CITY OF BETHLEHEM
INTER-DEPARTMENTAL CORRESPONDENCE

Project or Contract Reference: Amendment of Consulting and Engineering Services for Structural Evaluations at City Hall, Project No. MS-19-W01

CHANGE TO SCOPE/SCHEDULE/FEE

RE: Bethlehem City Hall Complex
Additional Deficiencies Discovered During Garage Investigation

Photo 1: Item #1- Bottom of Library Wall spall damage located under Library Main Entrance Stairs

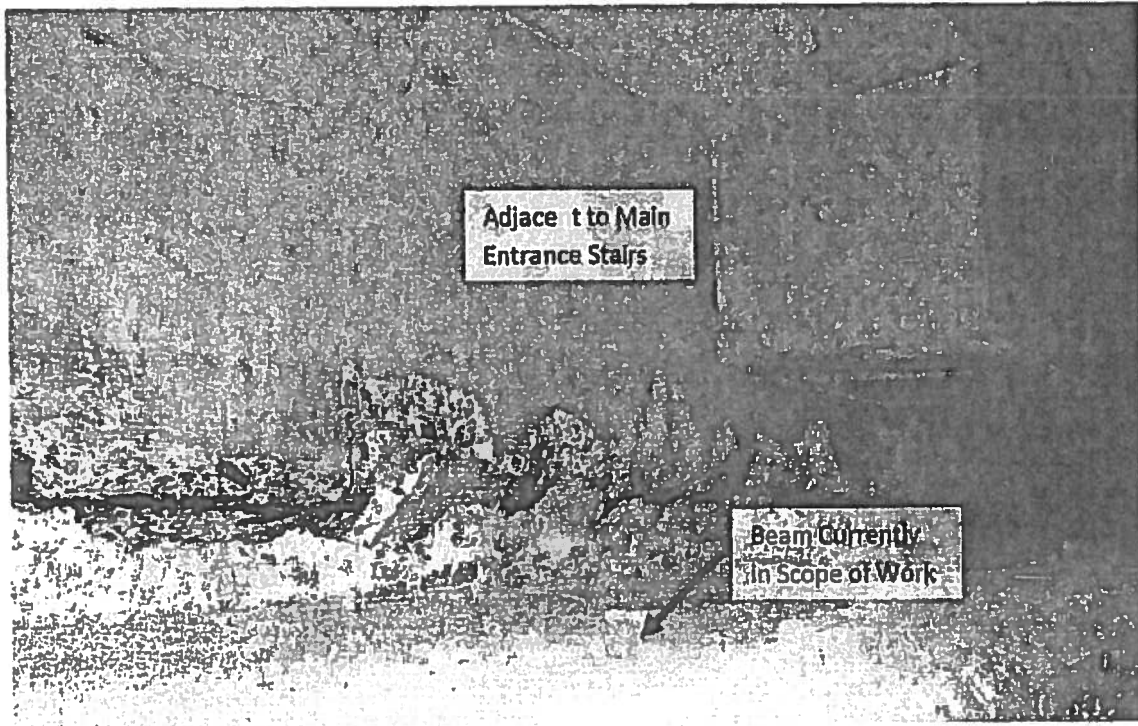
1. An approximate 65' long section of concrete wall was observed to have severe concrete spalling and damage to the bottom of the wall (Reference Photos 1-3 and SK-1). The wall is located directly under the library's main entrance steps and directly above the damaged plaza beam that is currently included in the scope of our repairs. From our review of the existing drawings, this wall appears to be an extension of the east wall of the library colonnade. The wall supports the granite benches and vertical panels around the perimeter of the library plaza/colonnade. It is our opinion that expanding the current scope of repair work to include the plaza wall will likely be the most cost-effective option.

Photo 3: Item #2- Failed Expansion Joint at Library Colonnade Wall

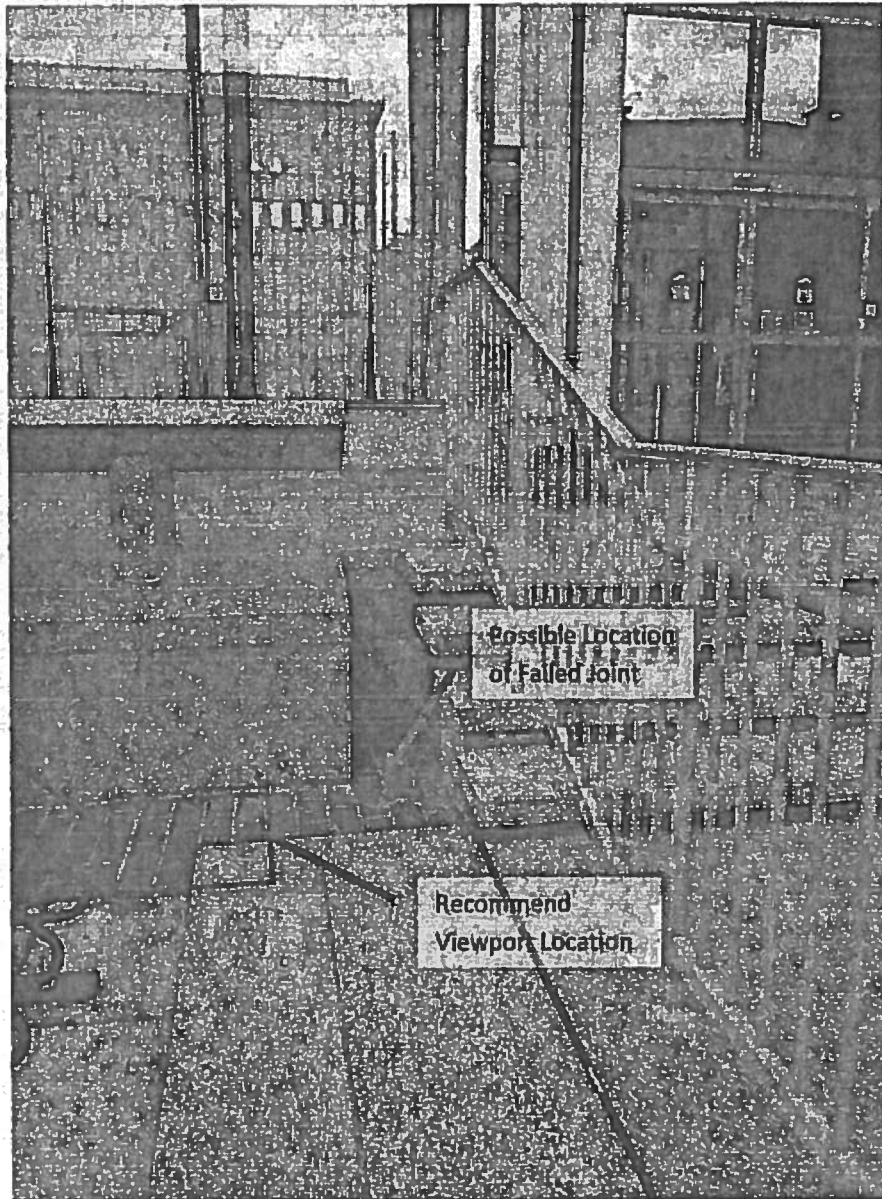
2. An approximate 40' section of the 1-1/2" expansion joint located at the center of the plaza, near the southeast corner of the library colonnade (Reference Photos 4-6 and SK-2). The failure has resulted in significant water infiltrating the garage area below the joint location. The water infiltration appears to have contributed to the parking garage slab deterioration below this area. We recommend that exploratory viewports be opened in order to investigate the condition of the expansion joint and determine possible repairs. The viewport would likely involve the removal of brick pavers at several locations (Reference Sk-2 and Photo 5).

Photo 6: Item #2-Water infiltration due to failed expansion joint at columns/spalled concrete

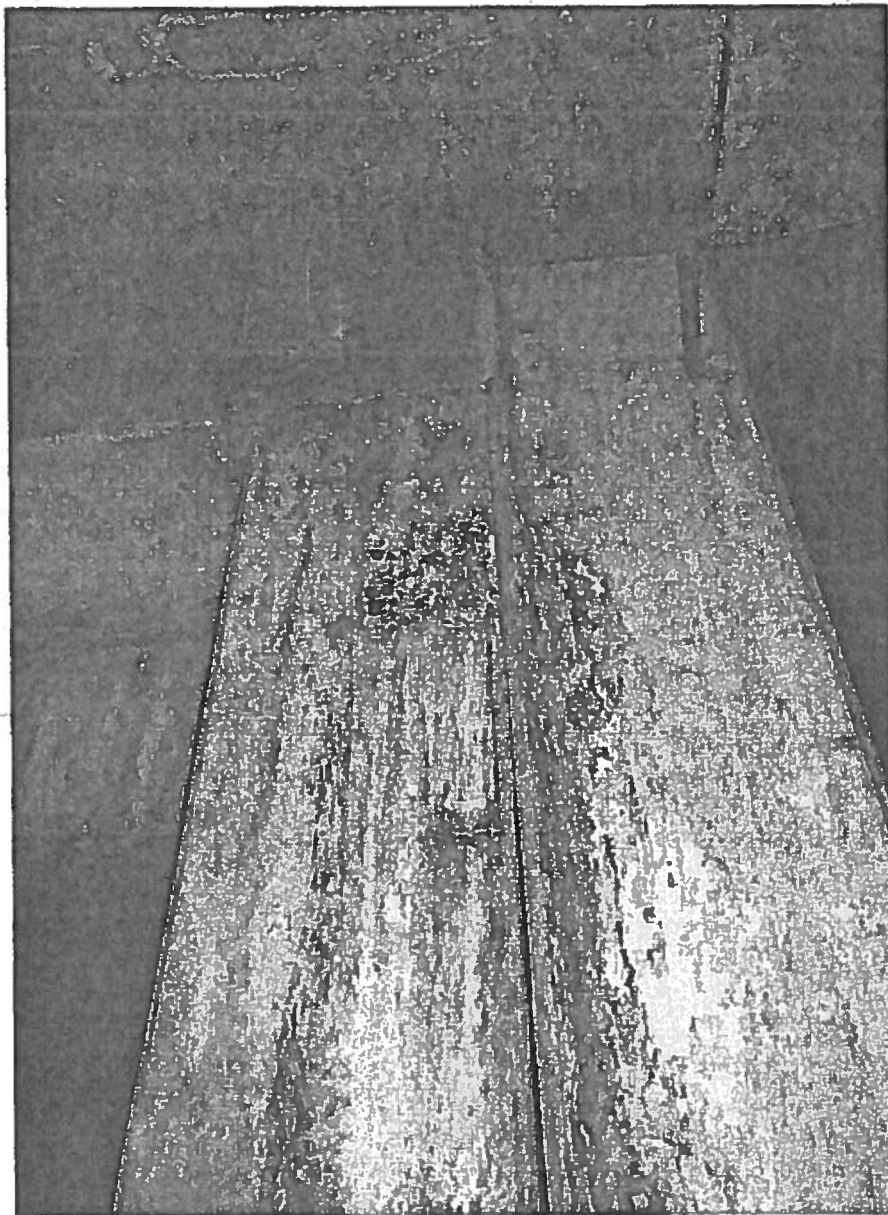
3. Multiple concrete columns located in the garage were observed to have areas of concrete spalling primarily located at the base of the columns (Reference Photos 6-7 and SK-2). Expanding the current scope of repairs to include the columns with the parking garage slab repairs will likely be the most cost-effective option.
